**RE: McDonald's – 5001 Gibson SE
Grading and Drainage Plan
Stamp Date: No Stamp Date
Hydrology File: L18D053**

Based upon the information provided in your submittal received 11/29/2017, the Grading and Drainage Plan **is not** approved for Building Permit. The following comments need to be addressed for approval of the above referenced project:

GRADING PLAN

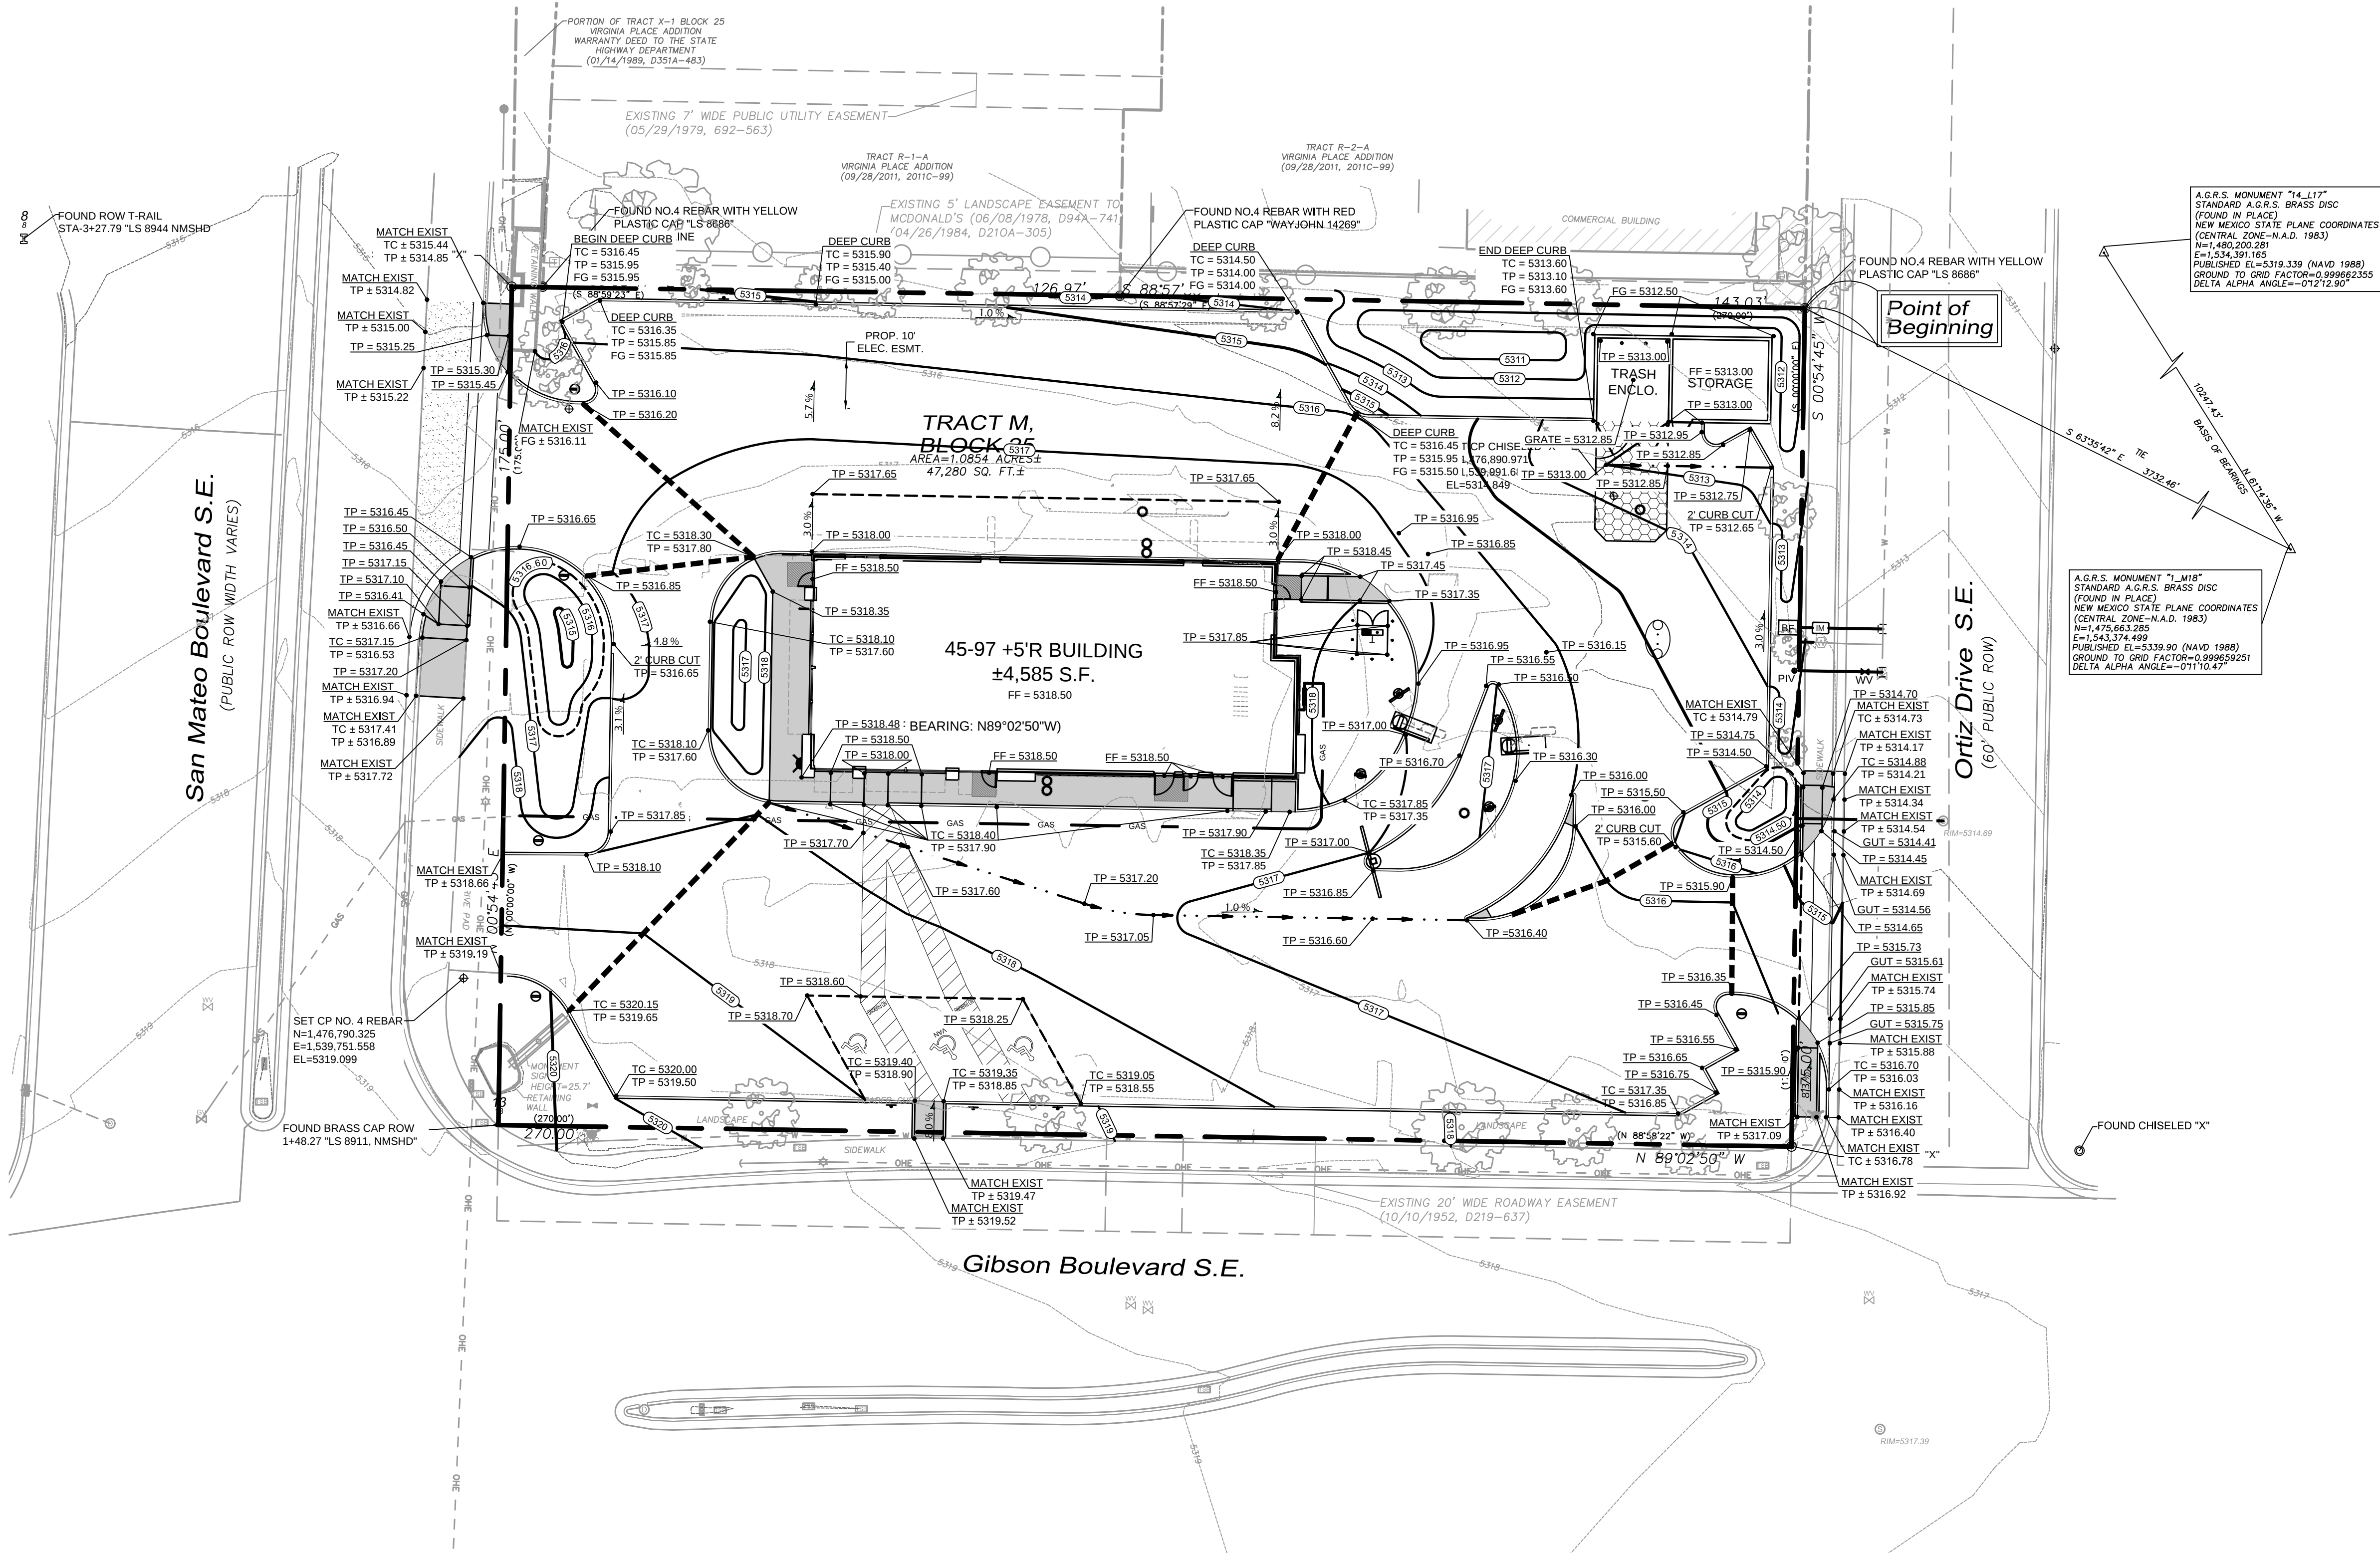
1. Please provide an engineer's stamp with a signature and date.
2. The site currently shows more than 1 acre of disturbance is being proposed. An Erosion and Sediment Control (ESC) Plan is required and has to be submitted to the storm water quality engineer (Curtis Cherne, PE, ccherne@cabq.gov). Hydrology's approval for Grading or Building Permit will not be given until the submittal of the ESC Plan.

3. Please provide the FIRM Map and flood plain note with effective date.
4. Please provide a vicinity map showing the location of the site. Typically this is the Zone Atlas. This can be downloaded in pdf format from the City of Albuquerque's website.

5. Please provide drainage calculations. Use the procedure for 40 acre and smaller basins as outlined in Chapter 22, Part A of the Development Process Manual (DPM). Please provide both the existing conditions and proposed conditions for the 100 year-6 hour storm event.

6. Please provide a paragraph stating the Existing Conditions and one stating the Proposed Conditions.
7. Please provide the first flush calculations and show each pond volume on the plan at each pond. All new development projects shall manage the runoff from precipitation which occurs during the 90th Percentile Storm Events, referred to as the "first flush." The Site Plan/Drainage Plan must indicate all areas and mechanisms intended to capture the first flush. For volume calculations, the 90th Percentile storm event is 0.44 inches. For Land Treatment D the initial abstraction is 0.1", therefore the first flush volume should be based on $0.44'' - 0.1'' = 0.34''$ and only consider the impervious areas.

8. Please provide wier calculations (Chapter 22 of the DPM) for the two foot curb cuts.
9. Please provide a curb cut at the north side of the property where there is a first flush pond. The runoff needs to get to the pond.

10. Please show how the drainage is going from the proposed first flush ponds to the street curbs. Please note that runoff cannot travel over the sidewalk or ADA ramps. Please use sidewalk culverts. Then please reference City of Albuquerque standard detail No. 2236 – Sidewalk Culvert with Steel Plate Top at the sidewalk culverts.
